CNRO-2005-00046

SUBJECT: Response to Request for Additional Information to Resolve the Grand Gulf Early Site Permit draft Safety Evaluation Report Open Item 2.5-3

### Additional Information Regarding NRC Open Item 2.5-3

**Figure 1. Comparison of response spectrum for original Grand Gulf controlling earthquake at 5-10Hz, and controlling earthquakes at 5-10Hz assuming 5 and 10% contribution to hazard from the SRSZ.**

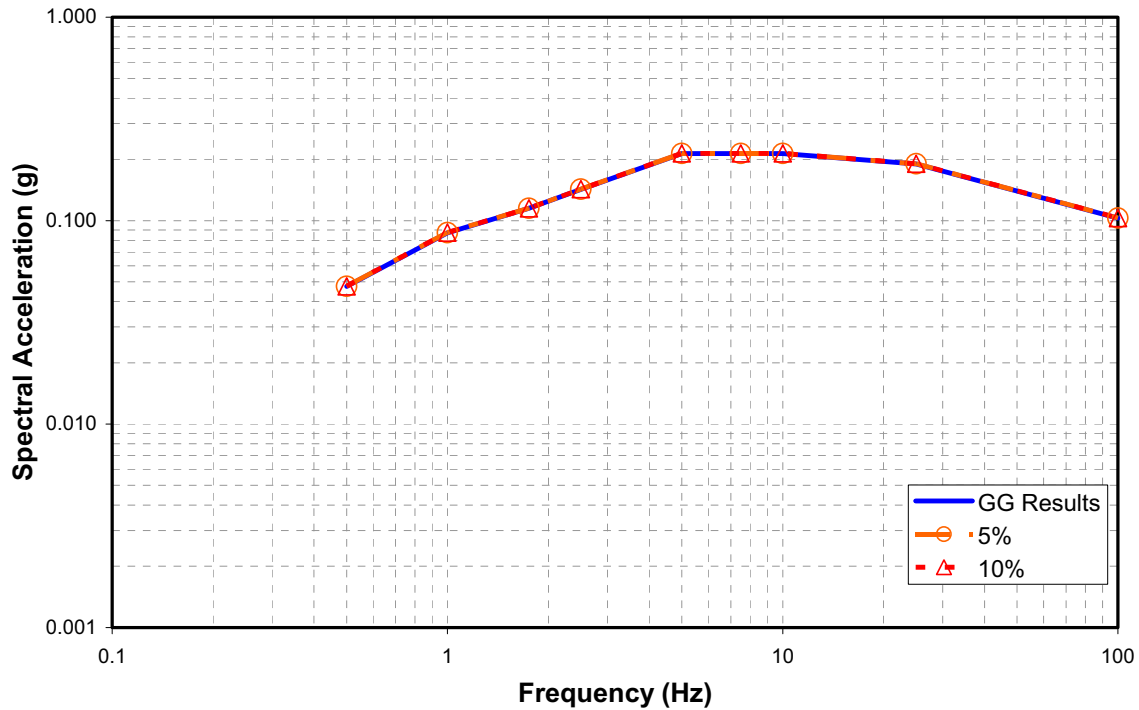
In their evaluation the USGS estimated the contribution of the Saline River source to the  $10^{-5}$  median ground motion for the average spectral acceleration for 5 and 10 Hz could be between 5 and 10 percent. The Applicant agreed to evaluate the sensitivity of this contribution to the 5 – 10 Hz controlling earthquake and resultant spectral shape for postulated SRSZ contributions of 5% and 10%. The NRC staff agreed that if there was no sensitivity to the site response spectra, this would be sufficient to close this open item. The results of this sensitivity analysis are presented below.

A sensitivity analysis was completed to evaluate the influence on the estimate of the controlling earthquake for the average spectral acceleration between 5 and 10 Hz and the resultant rock response spectra, assuming that the SRSZ contributes between 5% and 10% to the median  $10^{-5}$  ground motion at the Grand Gulf ESP site.

Changing the relative contribution of the SRSZ results in a slight decrease in the  $S_a(5-10\text{Hz})$  controlling earthquake (Table 1). The response spectra based on the original controlling earthquake and the alternative controlling earthquakes (assuming 5% and 10% contribution to hazard from SRSZ) are compared on Figure 1. The comparison indicates there is a very small difference in the rock ground motions. The percent differences for spectral ordinates are shown in Table 2.

The results of the sensitivity analysis indicate there is a very small change in the 5 to 10Hz controlling earthquake (Table 1) and associated median rock response spectrum (Figure 1) assuming a 5 or 10 percent contribution to the  $10^{-5}$  median hazard from the SRSZ. The differences in response spectral values range from +0.06 to -0.23% of the comparable Grand Gulf spectra (Table 2). Therefore, based on the assumed 5 to 10 percent contribution to the hazard from the Saline River Source Zone used in this analysis, there is less than a 0.23% difference in the computed spectral accelerations.

As a result of the sensitivity calculations, we conclude that a change in the relative contribution of the SRSZ of 10 percent would not result in a significant change to the median rock ground motion at the Grand Gulf site and thus not produce a significant change in the estimate of the Safe Shutdown Earthquake.
